DOCUMENT 009113 – ADDENDUM FIVE

- A. Project Name: Small Craft Harbor Pedestrian Overpass, Biloxi, Mississippi
- B. Project Location:
- C. Owner: City of Biloxi
- D. Architect Project Number: 17069
- E. Date of Addendum Five: August 3, 2018

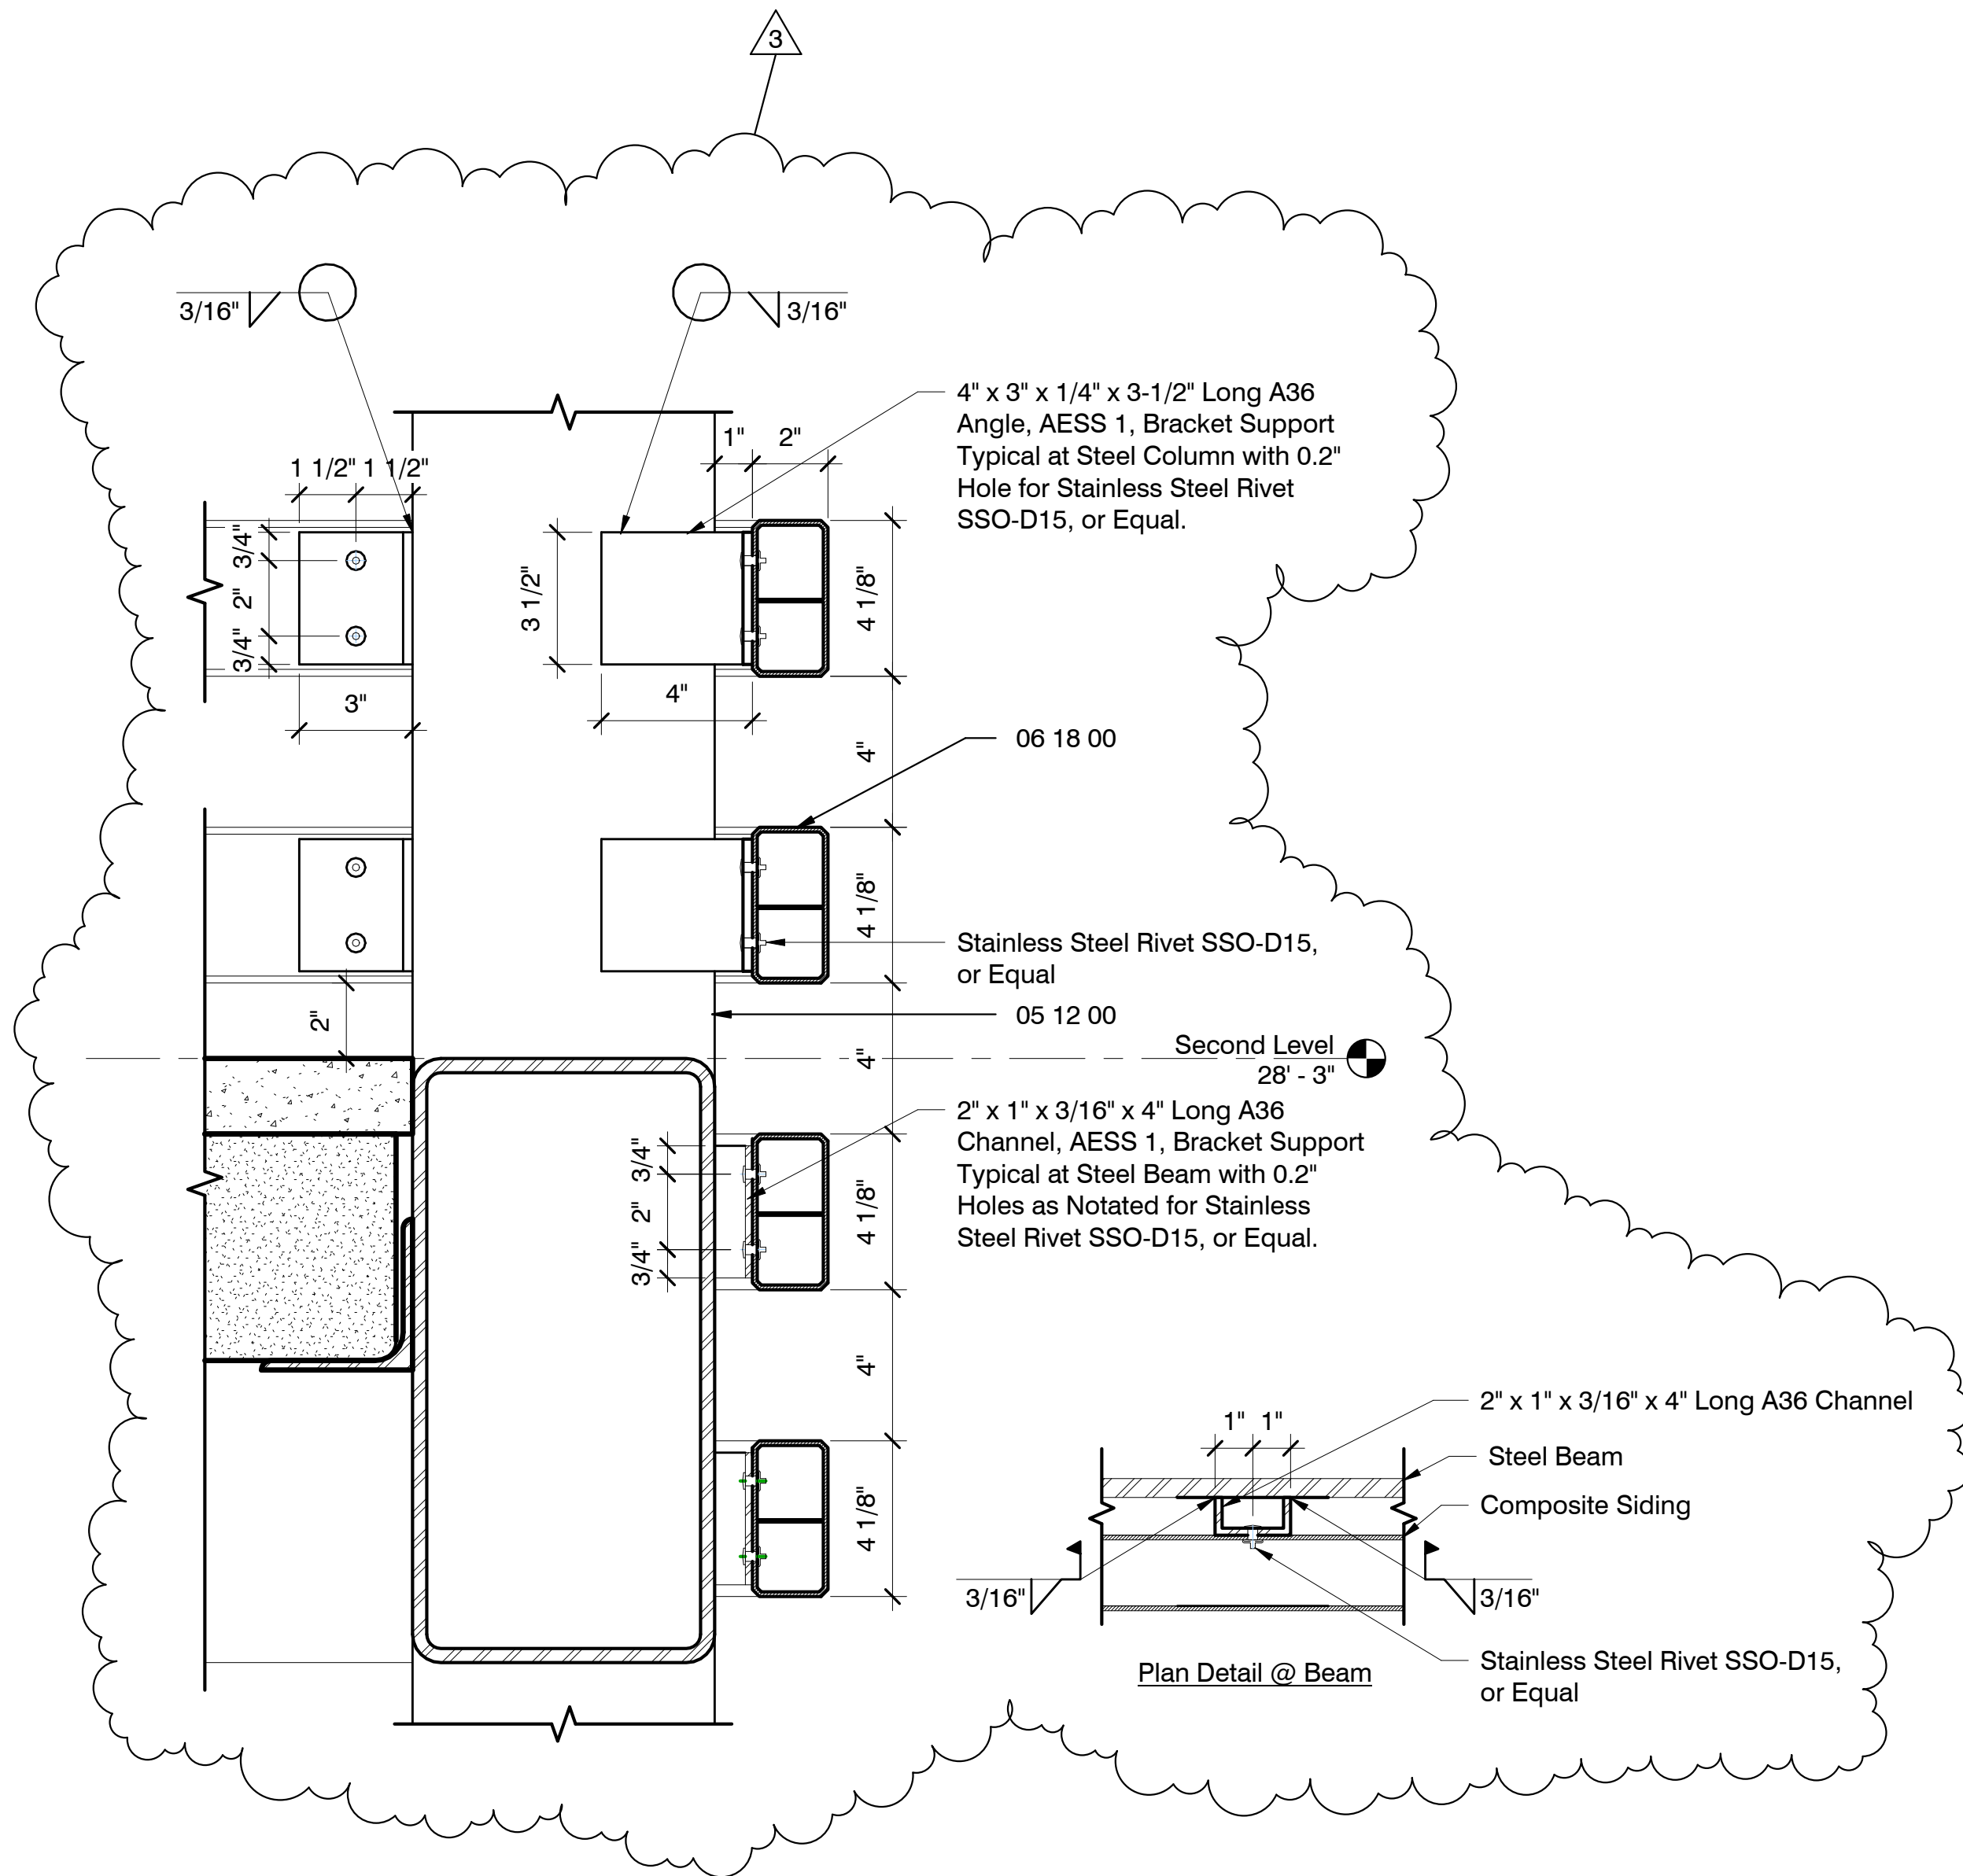
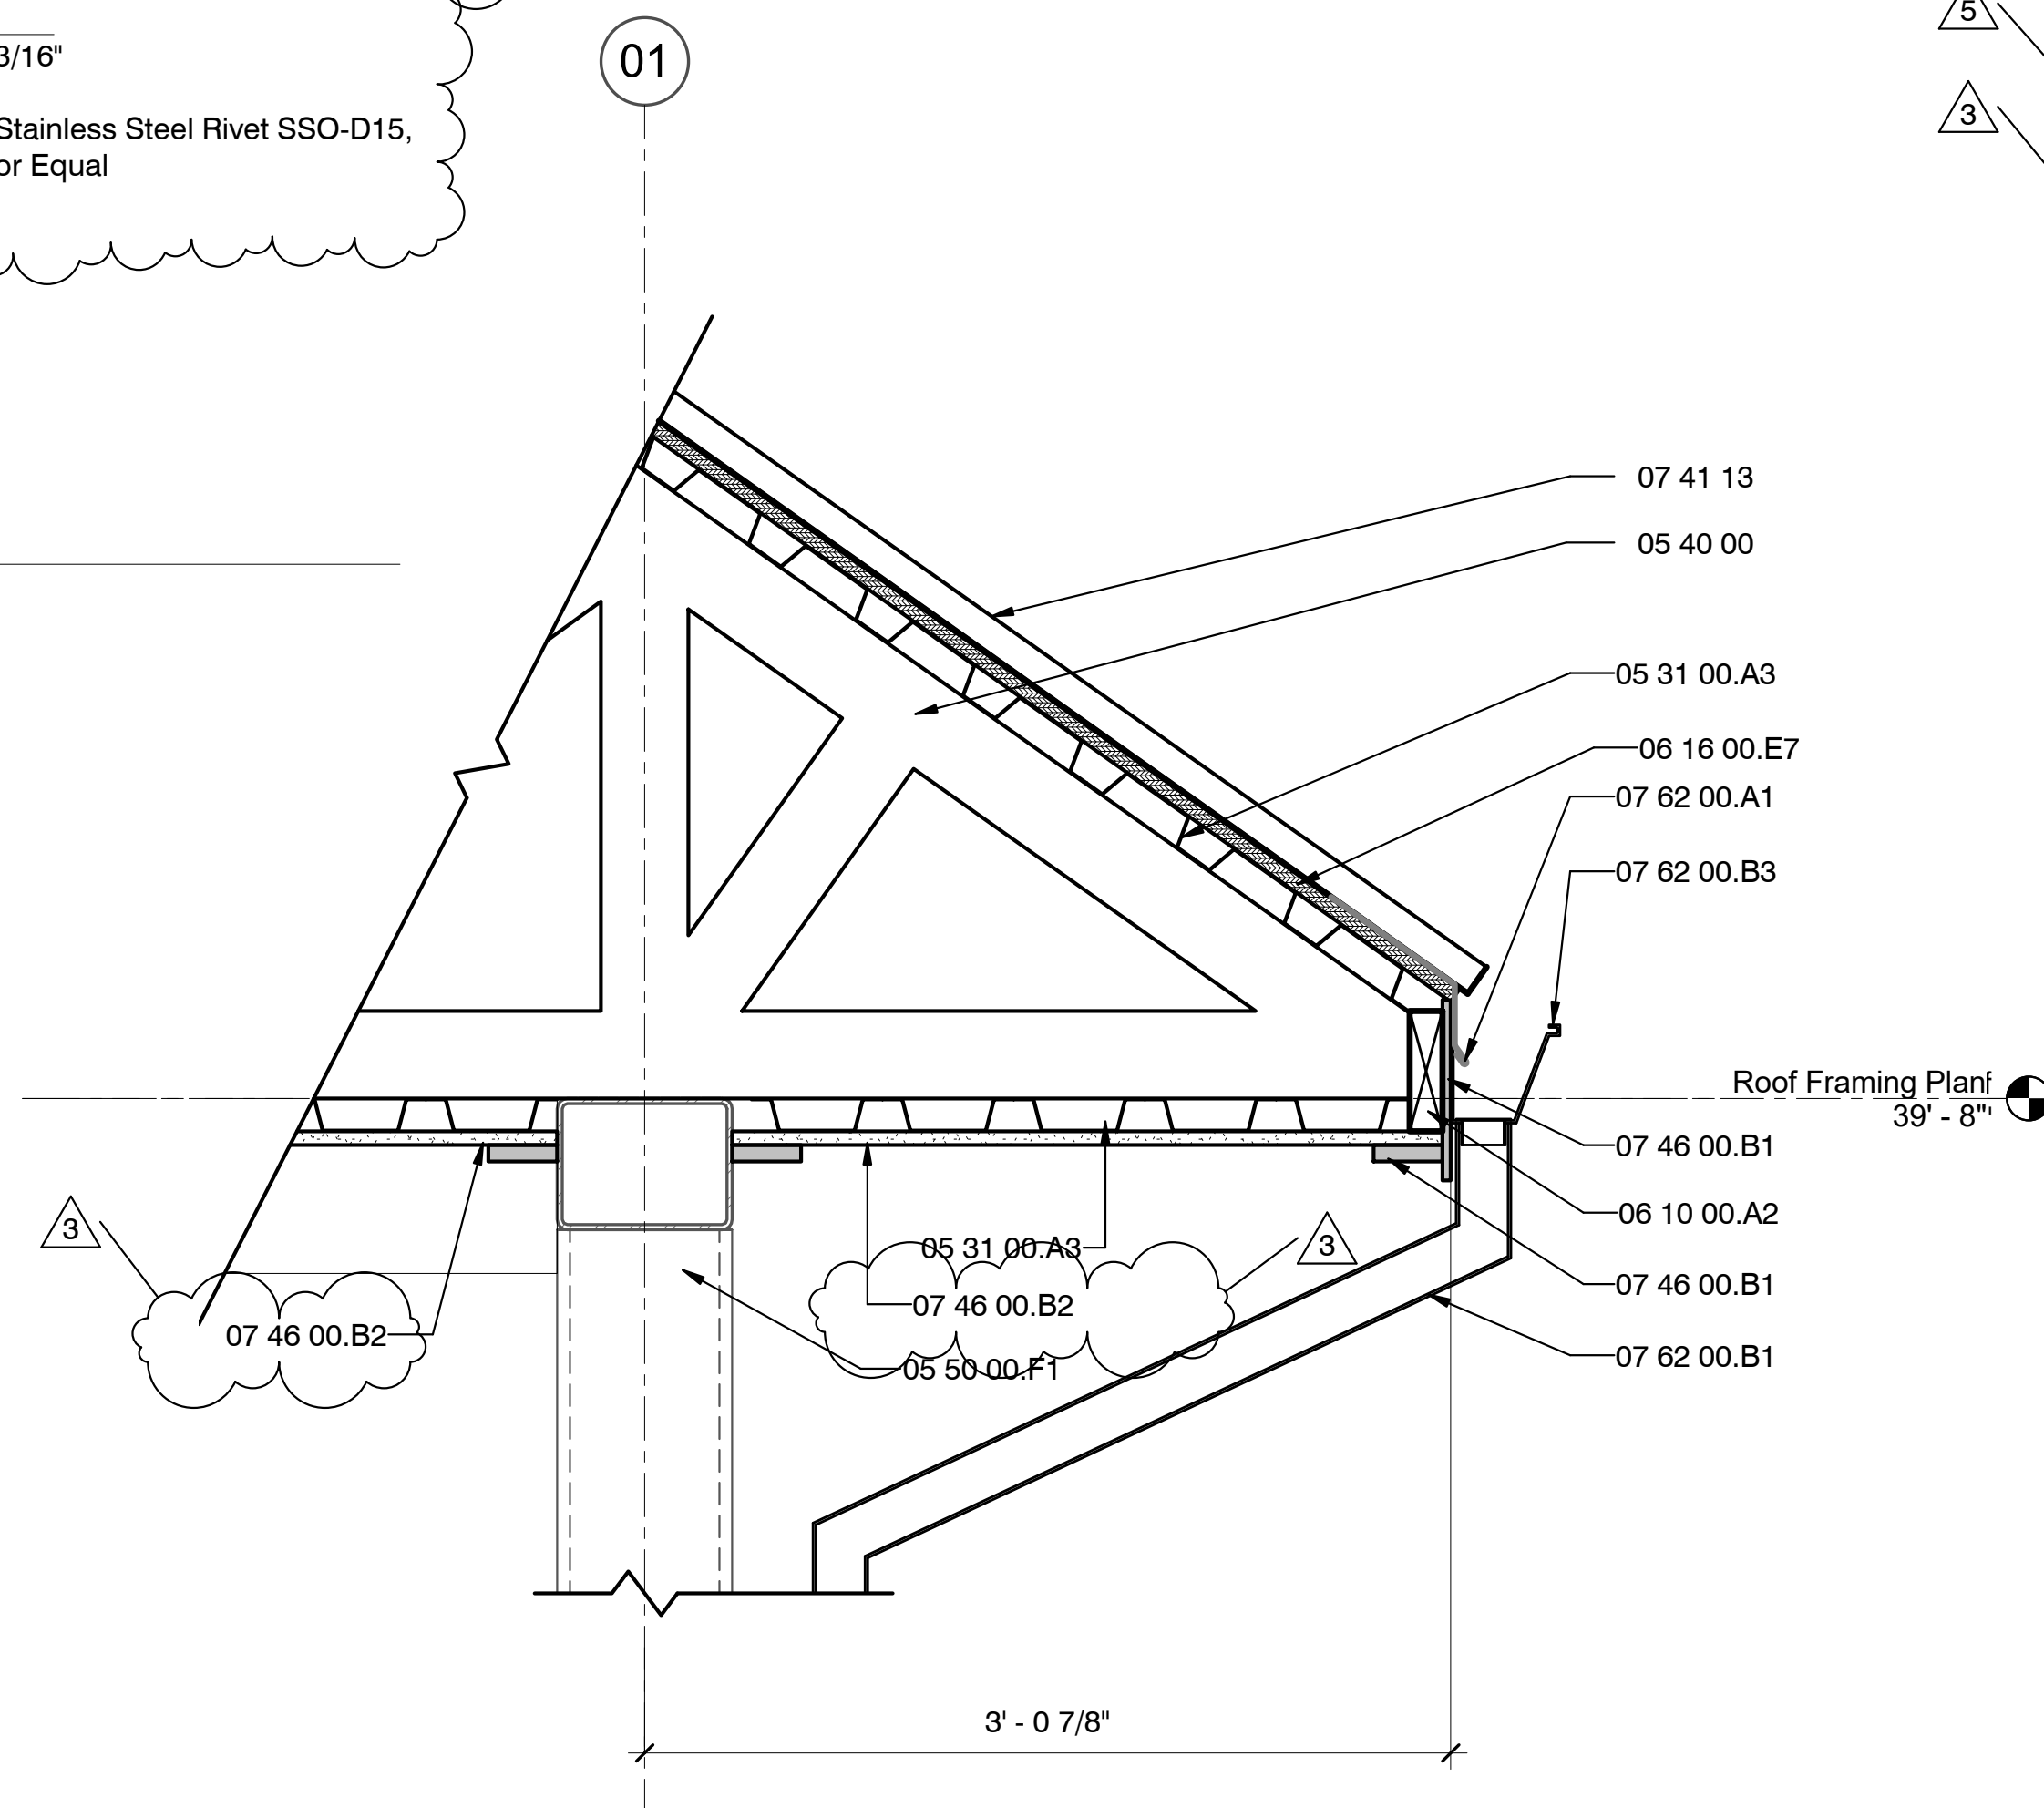
- E. QUESTION: The drawings do not indicate waterproofing on the CMU walls. Is the fluid-applied membrane air barrier system or block sealer to be applied in these locations?

1. New specification section. Please add this to the project manual.
- 1.7 REVISIONS TO DRAWING SHEETS
- A. Architectural Drawing A-501- Exterior Details, (Re-Issued): Fluid-Applied Membrane added.

ANSWER: Fluid-Applied Membrane shown in Re-issued Architectural Drawing A-501 and Issued Specification Section 072726 both by Addendum.
